February 10, 2020

Re: Site C Clean Energy Project - Proposed Design Changes to Highway 29 Crossings at Farrell Creek, Dry Creek and Lynx Creek

Table 1. Proposed Revisions to EIS Section 4.3.4.1, Table 4.5

Figure 4.30 General arrangement of Highway 29 realignment segment at Farrell Creek			
Date	Nov. 23, 2012	DWG NO	1016-C14-B6158-16 R 0

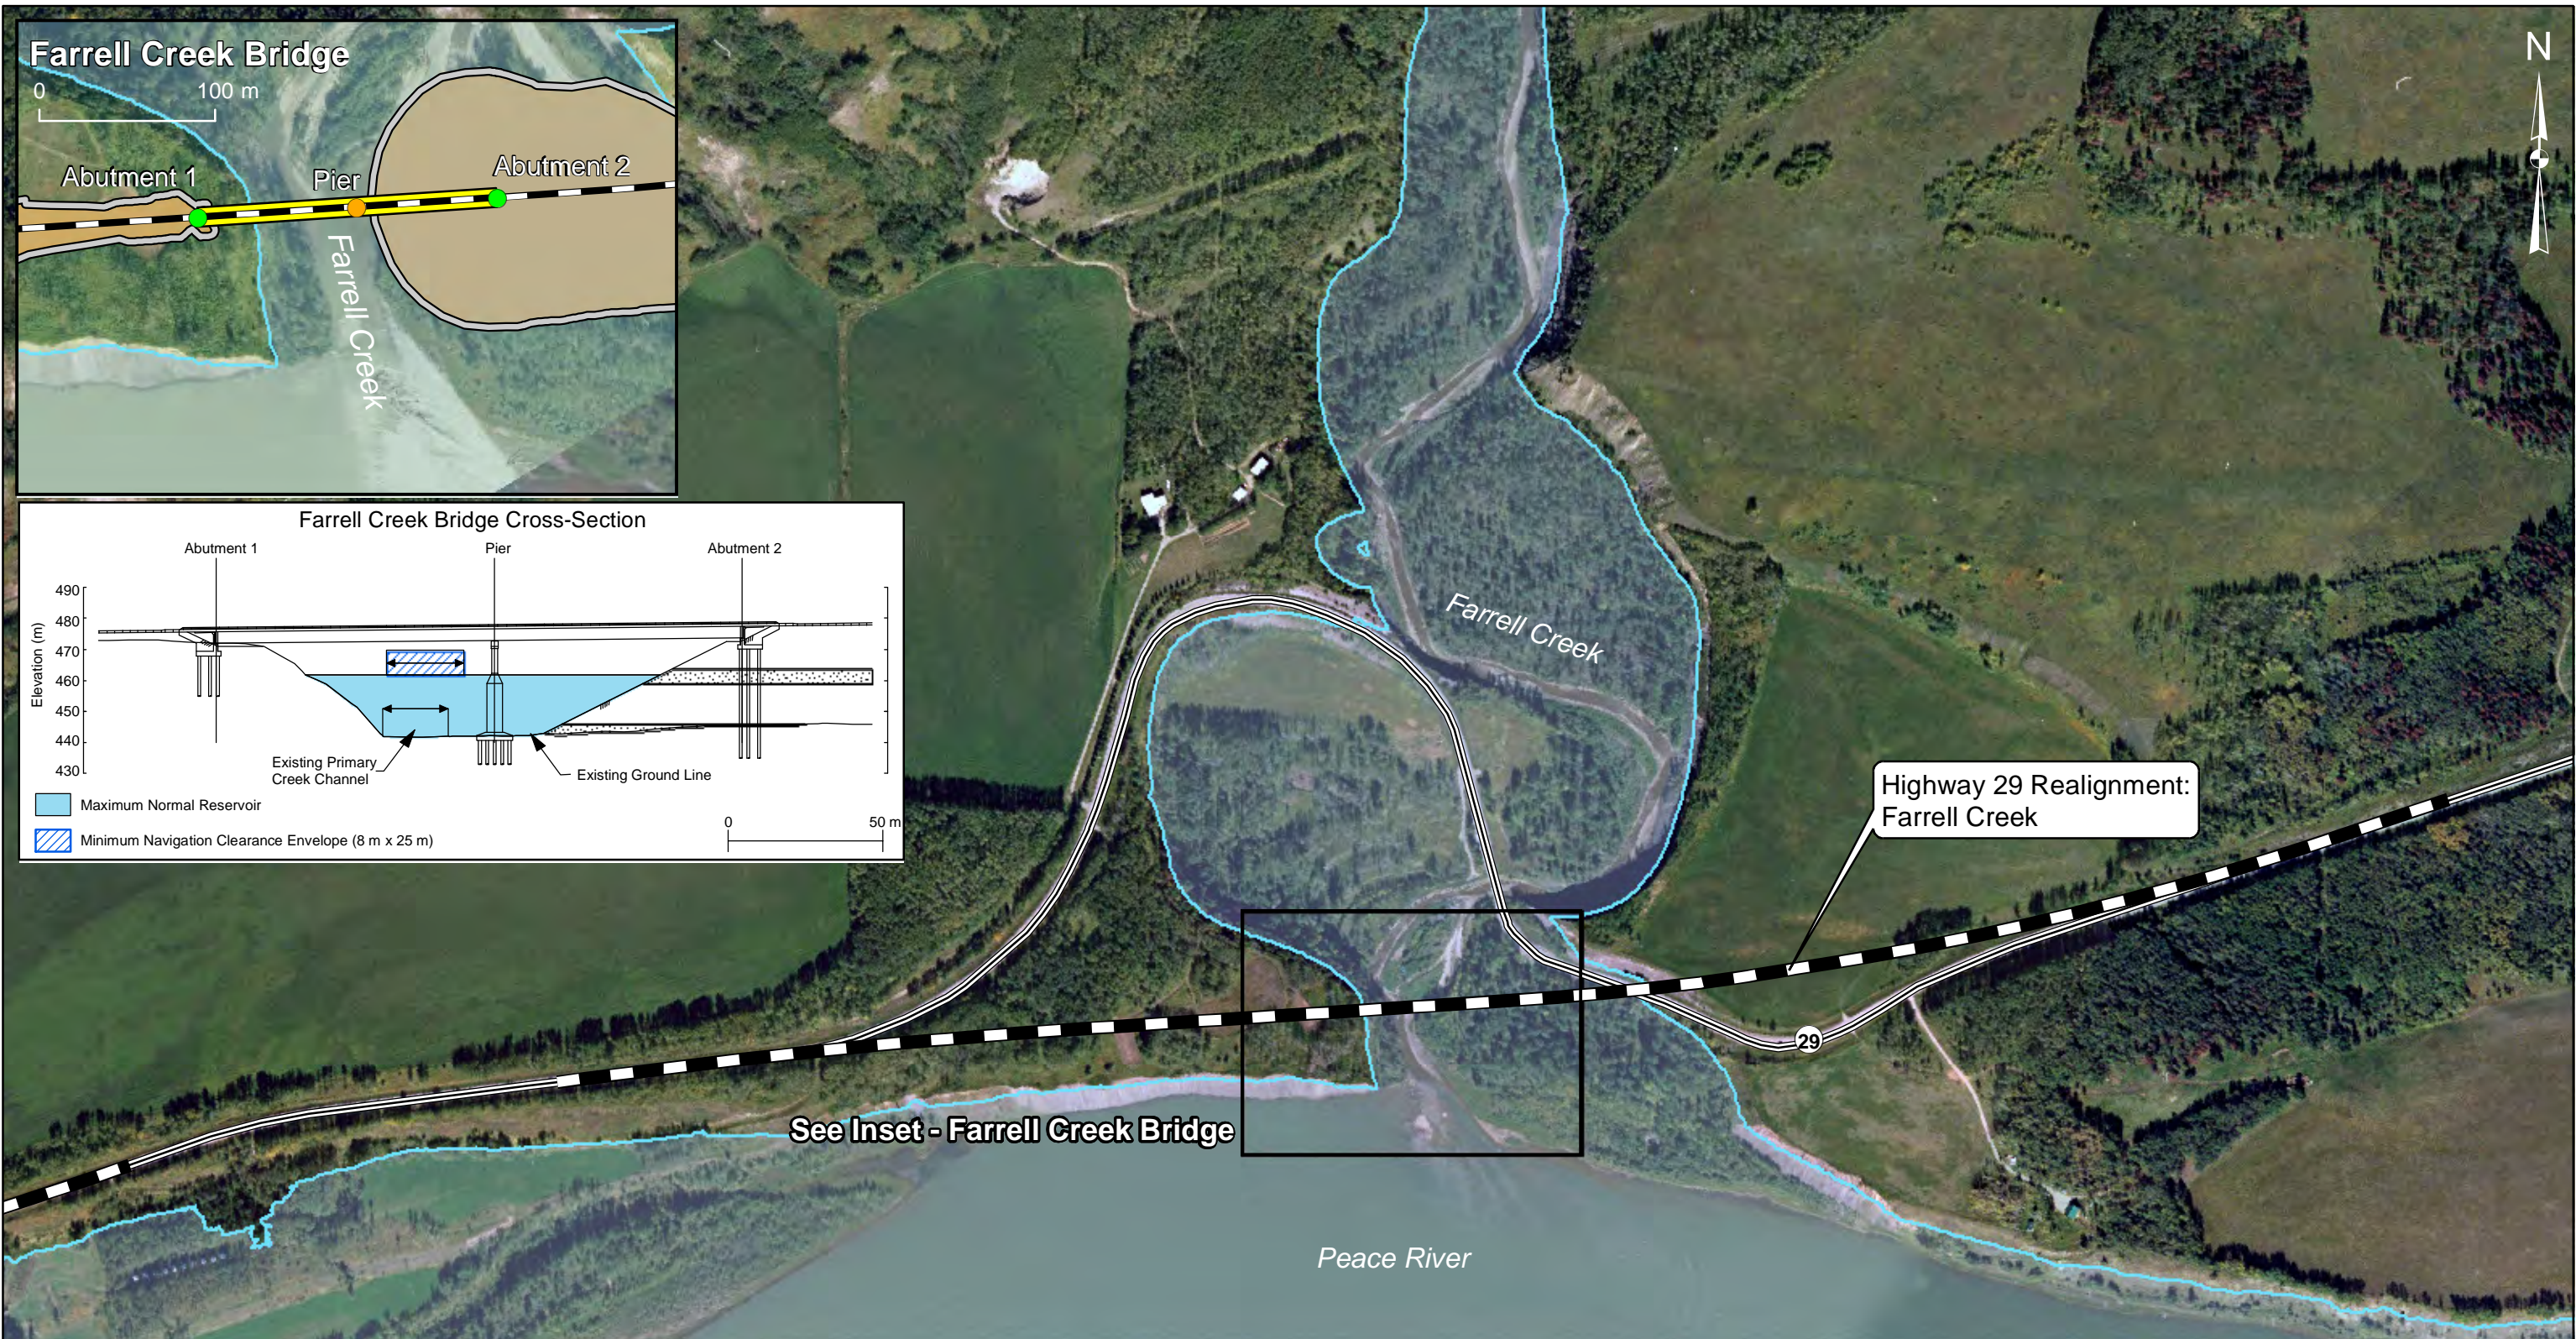
BC Hydro is proposing to replace the short bridge plus causeway option described in the EIS with a long bridge without a causeway that will be up to 450m long. BC Hydro is therefore proposing the following revisions to EIS Section 4.3.4.1, Table 4.5:

As shown in Figures 2, 3 and 6, the proposed design changes to the crossing will not materially change the alignment of the crossing, with the revised bridge design a few degrees offset from the EIS causeway. Overall, the removal of the causeway will reduce the environmental impact of construction below the future reservoir during the years leading up to inundation.

Component	EIS Text	Proposed Revisions to EIS Text
Highway 29 Realignment Farrell Creek Crossing	Section 4.3.4.1, Table 4.5: Highway 29 Realignment Segments and Respective Watercourse Crossing Lengths For Farrell Creek: Total Length of Segment: 2.0 km Causeway Length: 150 m Bridge Length: 170 m Number of Piers: N/A ⁴ Number of Bridge Spans: 2 Figure Number: Figure 4.30 Rev 0 (attached as Appendix A, Figure 2)	Section 4.3.4.1, Table 4.5: Highway 29 Realignment Segments and Respective Watercourse Crossing Lengths For Farrell Creek: Total Length of Segment: 2.0 km Causeway Length: 0 m Bridge Length: up to 450 m Number of Piers: up to 6 Number of Bridge Spans: up to 7 Figure Number: Figure 4.30 Rev 1 (attached as Appendix A, Figure 3)

Figure 5: Profile of Farrell Creek Bridge, per proposed revised design (not to scale)

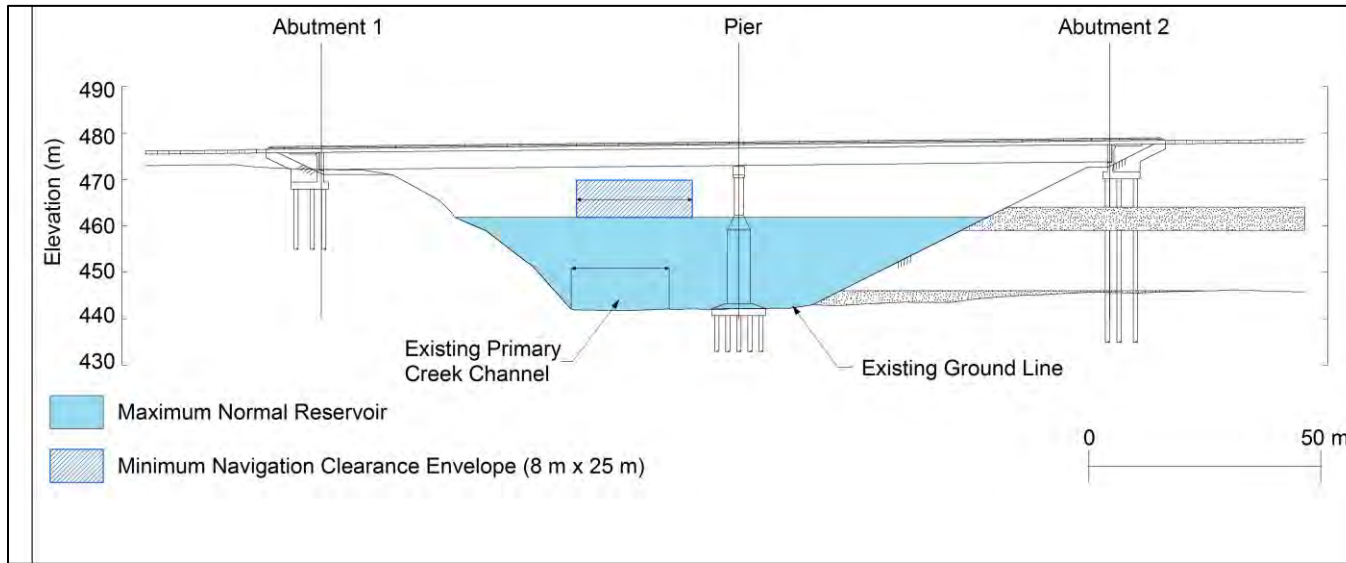
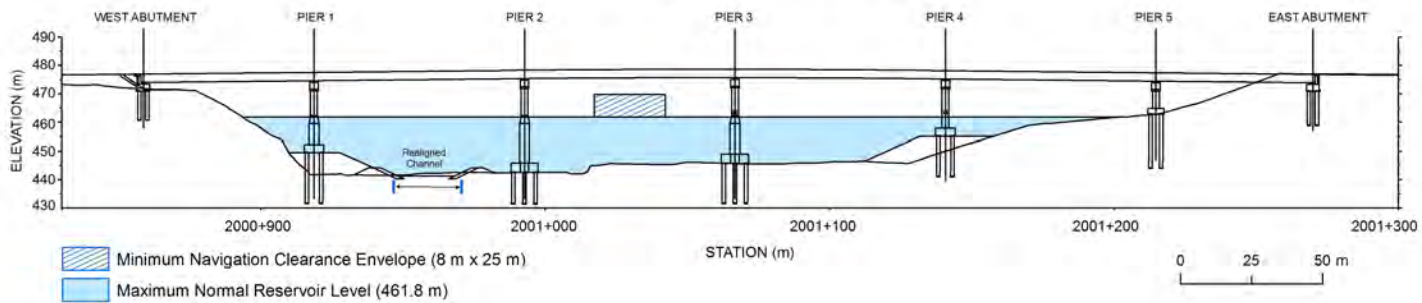
The assessment below is supported by information in Figures 4 and 5 – the EIS and Revised Design bridge profiles -- and Figure 6, a plan view of the EIS Schedule A bridge design versus the proposed revised design, post reservoir filling.

In addition, the overall boater access beneath the bridge is expected to improve as the revised design provides a wider wetted channel in the area below the bridge deck due to the elimination of the 150m causeway described in the EIS. Navigation channel marks and boater notifications for the modified bridge would meet all requirements for compliance under the *Canadian Navigable Waters Act*. No additional restrictions to boater access are expected to result from the changes to the design. Decommissioning of the existing Farrell Creek Bridge will be confirmed through discussions with Transport Canada and the Ministry of Transportation and Infrastructure. If the structure is left in place, the bridge deck will be 10.7m below minimum normal reservoir level of 460.0 m (i.e. existing bridge deck elevation = 449.3m), which will not interfere with boater traffic.

Figure 6: Farrell Creek Bridge - EIS vs Revised Design

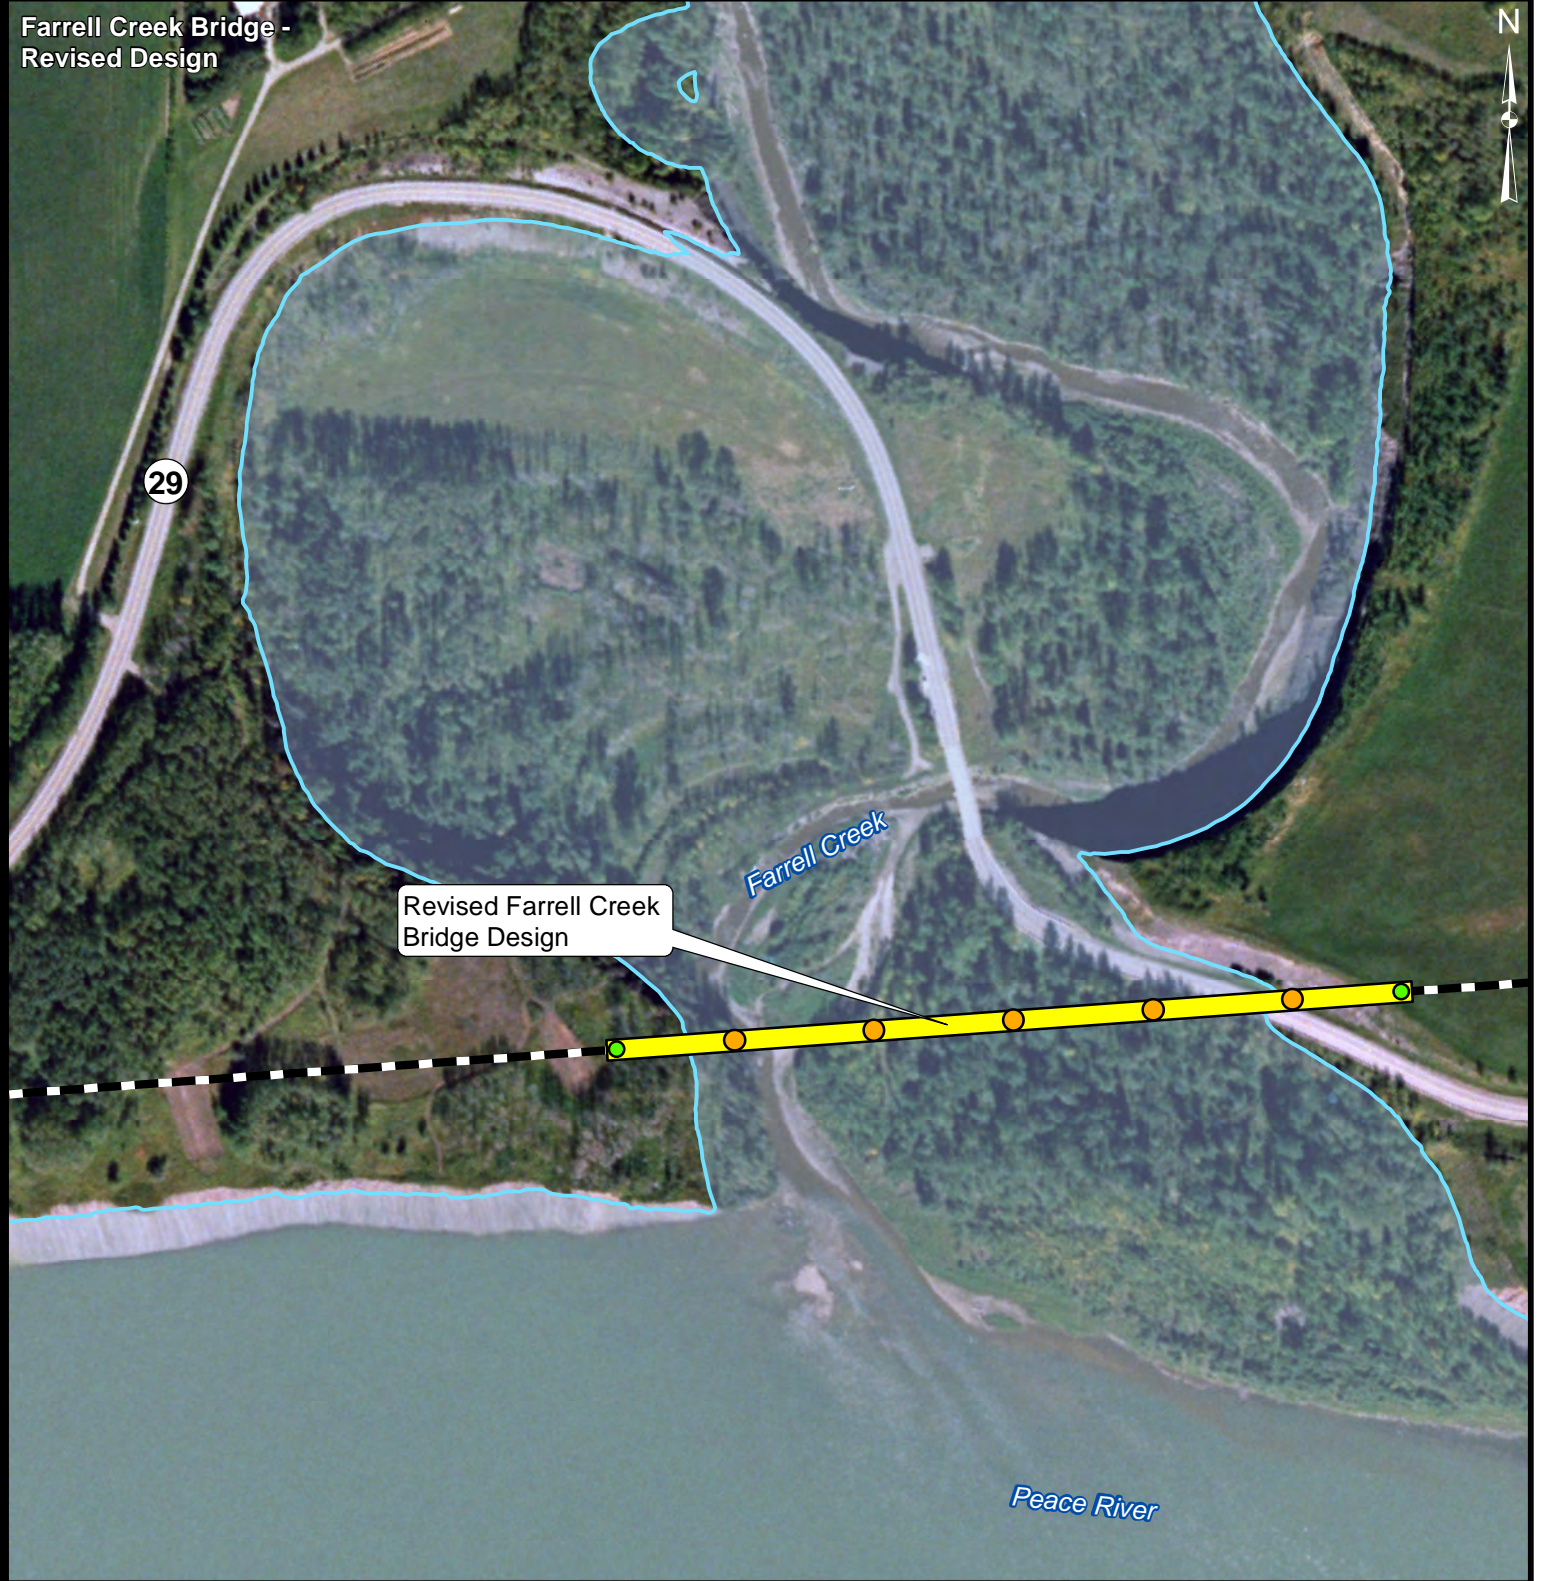
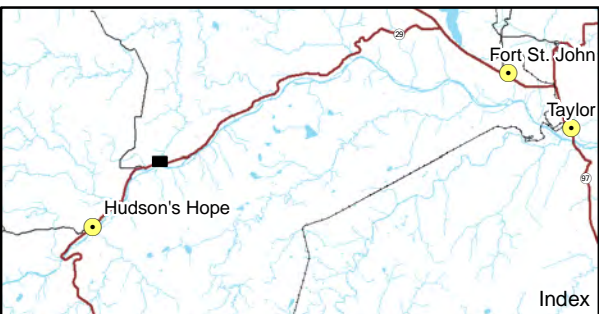
The proposed modification to the Farrell Creek Bridge design is not expected to cause any additional effects on vegetation and ecological communities or wildlife resources beyond those predicted in the EIS. As shown in Figure 6, the 150m causeway per the EIS design will be replaced by piers in the proposed revised design. This change does not increase the terrestrial footprint of the Farrell Creek crossing. Therefore, this revised design would not change the conclusions of the EIS regarding vegetation and ecological communities, or wildlife resources.
